Proposal Request

PROJECT: *(name and address)*
AWSOM
Bentonville, Arkansas

PROPOSAL REQUEST 042

Revised drawings in PR 042 update second floor BBH 44-46 and VAV 4-07 per coordination and responses from RFI #298.

① HVAC - LEVEL 2 PLAN - AREA A
 1/8" = 1'-0"

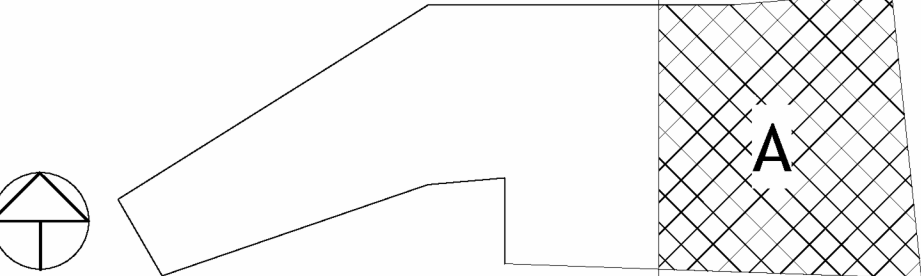
- a) Refer to Revised Sheet **M102A**, with original issue date 02.24.2023 and revised date 03.21.2024.
 - Revised air distribution from VAV 4-07.
 - Added note M205 to Mechanical Plan Notes.
 - Removed BBH 44-46.
- b) Refer to Revised Sheet **M202A**, with original issue date 02.24.2023 and revised date 03.21.2024.
 - Removed BBH 44-46 and associated piping.
- c) Refer to Revised Sheet **M600**, with original issue date 02.24.2023 and revised date 03.21.2024.
 - Added UP to Grilles, Registers, and Diffusers Schedule.
- d) Refer to Revised Sheet **M602**, with original issue date 02.24.2023 and revised date 03.21.2024.
 - Revised VAV 4-07.
- e) Refer to Revised Sheet **M603**, with original issue date 02.24.2023 and revised date 03.21.2024.
 - Removed BBH 44-46 from Baseboard Heater Schedule

- M114 BSH 47-48 SHALL BE CONTROLLED BY VAV 4-10 THERMOSTAT.
- M205 SUSPEND SUPPLY PLENUM ABOVE PANEL SYSTEM IN GAP SO THAT AIR DISCHARGES BETWEEN PANELS.
